historic Security Building

street & number 117 N. E. 1st Avenue

HISTORIC PRESERVATION CERTIFICATION APPLICATION
PART 2 - DESCRIPTION OF REHABILITATION

Security Bldg. Photo no.1
Ground floor
Non-historic ceiling &
steel support (I-Beams)
Mezzanine Area 7-12-00

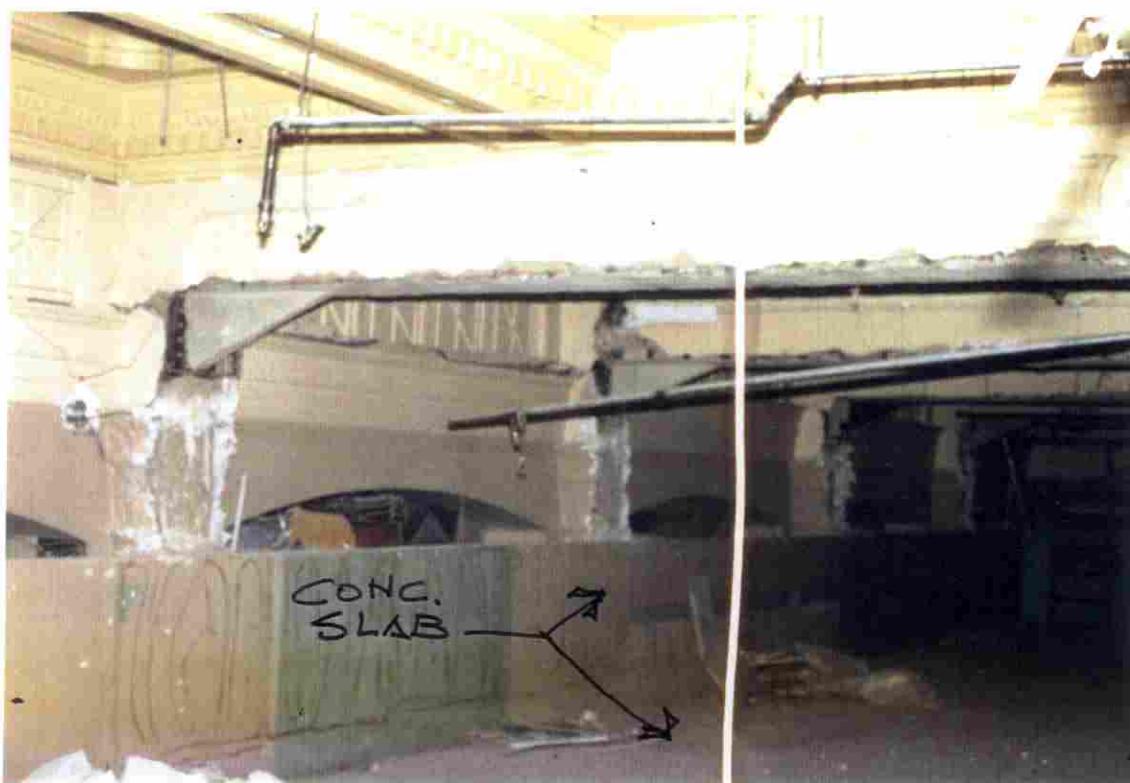
- 1) Labeled photographs showing what is above the modern ceiling on the first floor. Portions of the modern ceiling should be removed in different locations on the first floor to show the condition and appearance of the ceiling above, and any detailing, if it exists. These areas should then be photographed (we note that you documented the mezzanine/second-floor conditions in this manner).

Modern ceiling on the first floor has been removed (please see attached photos no.1 and no.2) to exposed non-historic steel frame and concrete slab. This concrete slab was added to divide the original two story mezzanine area into two spaces. This slab is to remain as stated in the Application. (please photo no. 28 submitted with Application). On the first floor entry area, ornamental historic ceiling remains above metal non-historic ceiling, this ceiling will be completely restored.

Security Building photo no.7
West facade, granite and
terra-cotta spalling.

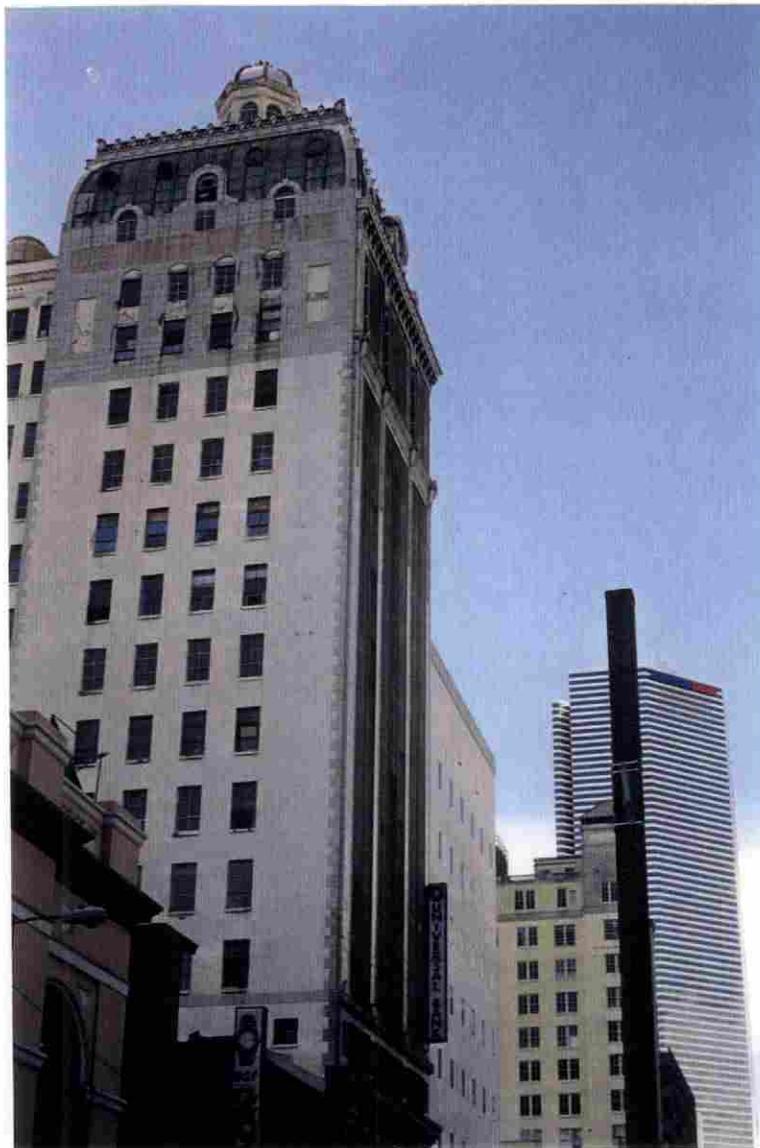
<table border="1"> <tr> <td>Number 5</td> <td>Architectural feature <u>West Facade</u></td> </tr> <tr> <td></td> <td>Approximate Date of feature <u>1926</u></td> </tr> </table>	Number 5	Architectural feature <u>West Facade</u>		Approximate Date of feature <u>1926</u>	<p>Describe existing feature and its condition:</p> <p>Granite and Terra-cotta panels spalling.</p> <p>Photo no. <u>7</u> Drawing no <u>HP-5</u></p>	<p>Describe work and impact on existing feature:</p> <p>Spalling will be repaired by removing all loose or friable material. All blistered areas will be coated and sealed. Panels which have lost most of its material and structural integrity will be replaced with complete units.</p>
Number 5	Architectural feature <u>West Facade</u>					
	Approximate Date of feature <u>1926</u>					
<table border="1"> <tr> <td>Number 6</td> <td>Architectural feature <u>West Facade</u></td> </tr> <tr> <td></td> <td>Approximate Date of feature <u>1926</u></td> </tr> </table>	Number 6	Architectural feature <u>West Facade</u>		Approximate Date of feature <u>1926</u>	<p>Describe existing feature and its condition:</p> <p>Holes and surfaces cracking in granite and terra-cotta panels created by signs and non-original awnings and metal screens.</p> <p>Photo no. <u>5-6-7</u> Drawing no <u>HP-5</u></p>	<p>Describe work and impact on existing feature:</p> <p>Existing holes and surface cracking will be permanently sealed with a sealer that will expand with the normal dynamics of the surrounding material. Restoration Mortar for Terra-cotta panels to be: Jahn M-100 Grouting if required to be: Jahn M-40 Or M-50 by Cathedral Stone Products, or approved equal.</p>

Security Building photo no.34
Typical Floor
Commercial alterations

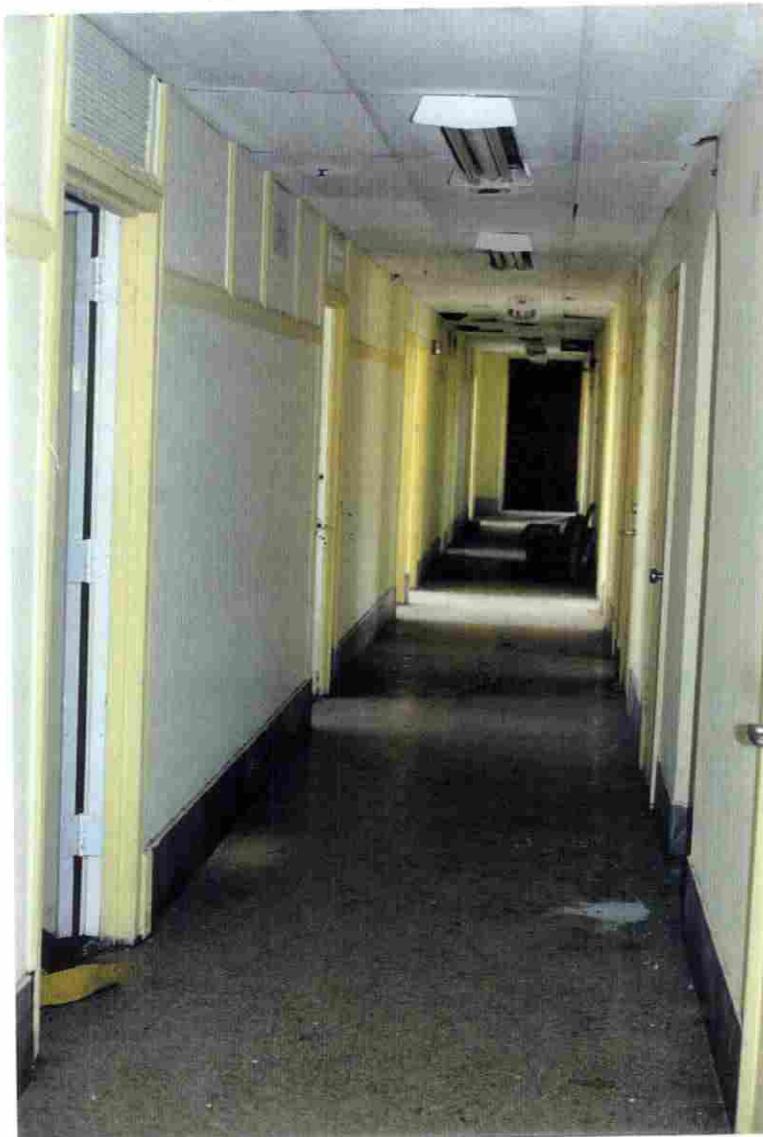
- 2) Labeled photographs of public corridors, elevator lobbies and representative spaces (including historic trim) on all floors above the first floor. (Please be advised that corridors in highrises, and any historic fabric that defines them, are important to preserve.) We note that your application includes just photos of the elevator lobby and details on the mezzanine level/second floor, and two unidentified corridors. Please key the photographs to plans, which you have already developed.

Photo no. 34 submitted with Application shows altered corridor at 7th floor looking east. All corridors were similarly altered as shown on this photo. These corridors have been removed. (please see attached photos of existing conditions). Photo no.35 submitted with Application shows original wood wainscot, door frames, blocked transoms and marble base at 5th floor looking east. Proposed corridors will have door entrances to follow new plan and walls will have the same treatment as shown on this photo.
